SERVICE LETTER

No. 675

Magneto Switch Guard Installation

PA-31 and PA-31-300 Navajo
PA-31-350 Navajo Chieftain
PA-31P Navajo

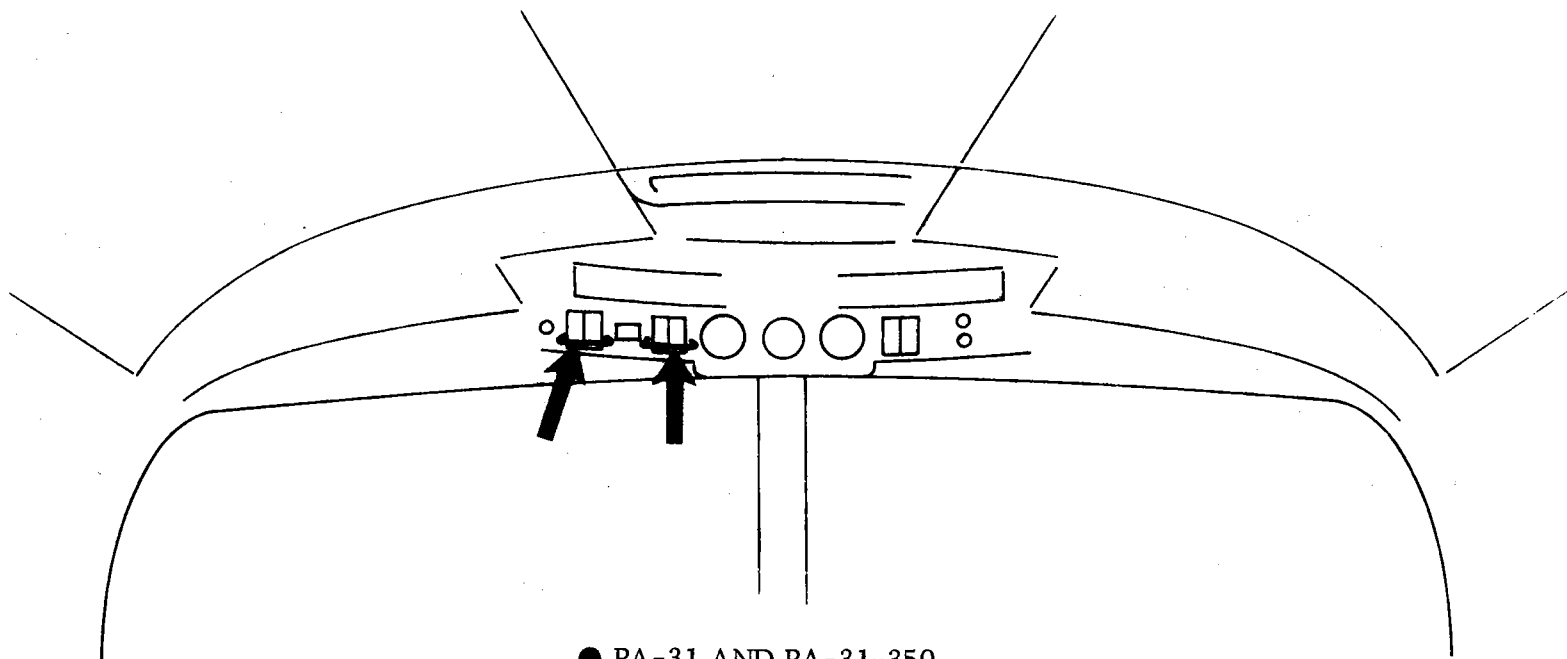
The magneto switches on the Navajo Series aircraft are located on the overhead instrument panel and are "rocker" type switches. Installation of the subject switch guards will assist in preventing inadvertent magneto switch shut-off. Refer to sketch on reverse side of this letter for a general illustration of the switch guard installation.
